Item 3.**Development Application: 422-424 Cleveland Street, Surry Hills - D/2020/993****File No.:** D/2020/993**Summary****Date of Submission:** 30 September 2020. Amended plans received 11 May and 12 August 2021.**Applicant:** Pyrafount No. 6 Pty Ltd**Architect:** JSA Studio**Owner:** Pyrafount No. 6 Pty Ltd**Planning Consultant:** Ethos Urban**DAPRS:** 7 December 2020**Cost of Works:** \$5,658,567.00**Zoning:** B4 Mixed Use Zone. The proposal is permissible with consent.**Proposal Summary:** Alterations and additions to the 'Kirk' building for a mixed use development including boarding house, cultural entertainment venue and café.

Figure 25: Height plane perspective drawing

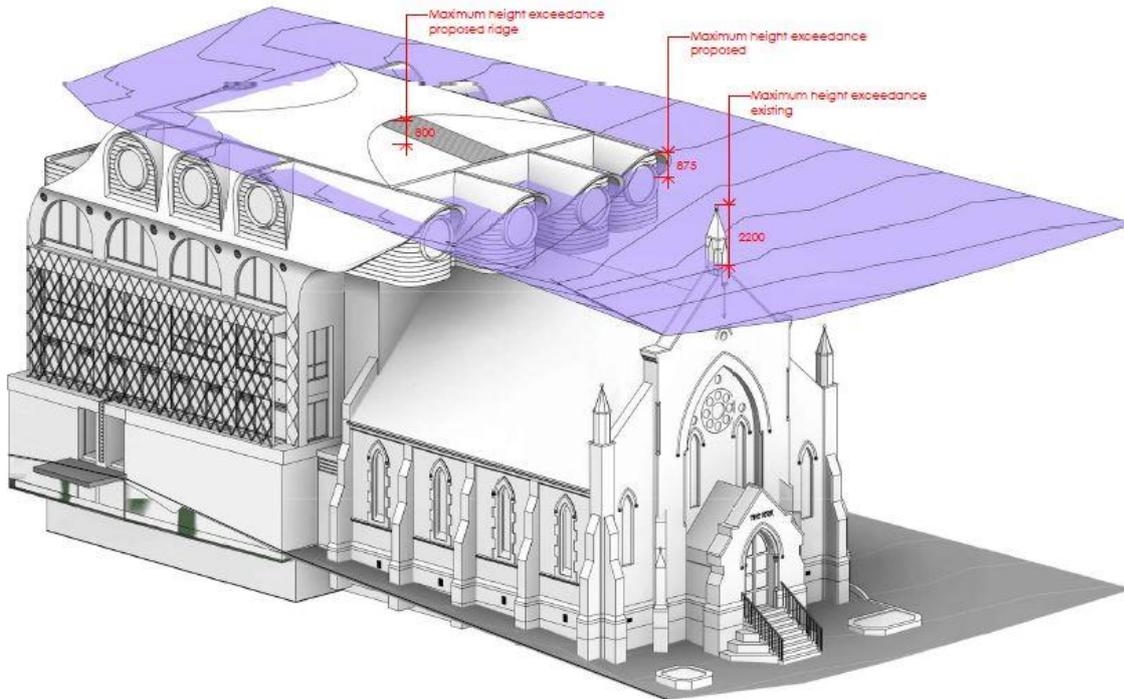
- (ii) Higher than minimum floor to ceiling heights of 2.7m are provided to maximise the amenity to boarding rooms. A minor breach in the height standard results for some rooms from the non-compliance. Strict compliance with the standard would require reduced floor to floor heights.
- (iii) The portion of the building which exceeds the standard is 875mm and is limited to a small area as illustrated in the height plane perspective view.
